From: Harmon Rita T.
Sent: Tuesday, January 12, 2016 9:51 AM
To: 'Jeff Wooten'; Cherne, Curtis
Cc: acarillo@cabq.gov; 'Scot McLelland'; 'John Wilger'; Abiel X. Carrillo
Subject: RE: 98th St Plaza Parking Lot Swales

From: Jeff Wooten [<mailto:jeffwooten.pe@gmail.com>]
Sent: Friday, January 08, 2016 4:47 PM
To: Harmon Rita T.; Cherne, Curtis
Cc: acarillo@cabq.gov; 'Scot McLelland'; 'John Wilger'
Subject: 98th St Plaza Parking Lot Swales
Importance: High

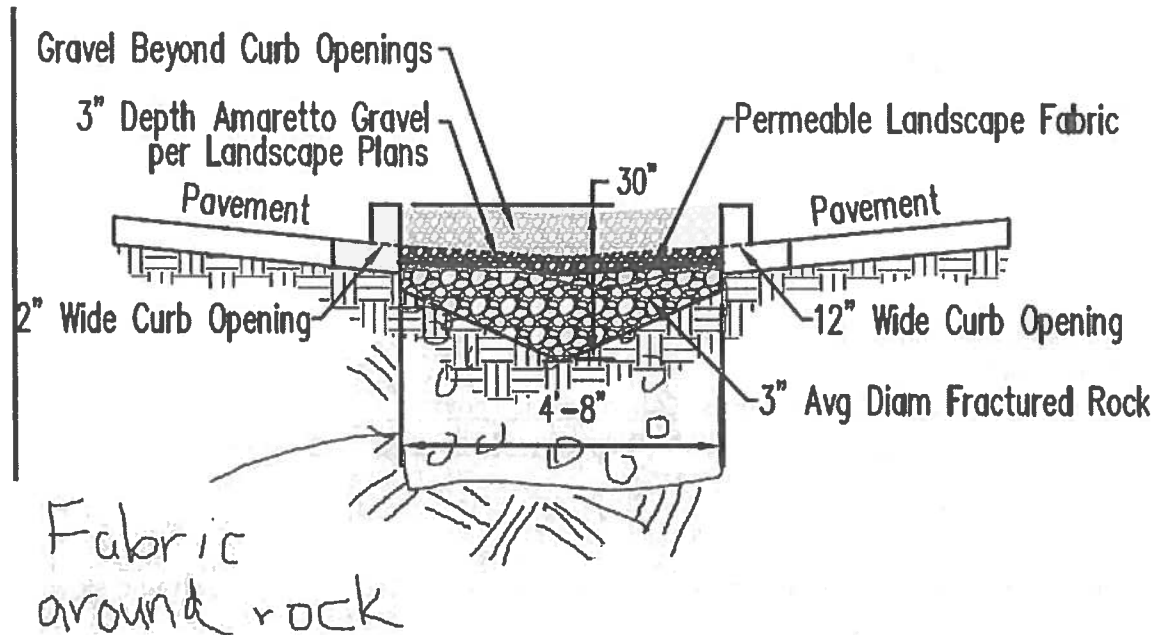
Yes. See attached details. The French drain is the bottom option.

Do you mean a French drain? If so, I think that is acceptable, as the water collected in the pipe should slowly dissipate and infiltrate into the surrounding rock and soil.
Rita

I think that is a good option as well. I am checking in with the GC to get their thoughts on constructability since the curbs are already installed.

What are your thoughts on the pipe option?

Jeff,
After speaking to Abiel about this, we think a recharge pit is the best solution.
Rather than a triangular cross-section, use a deeper rectangular section, filled with rock, and fabric all around.
Volume should be same as that required for first flush.

Jeff,
This detail works.
Rita
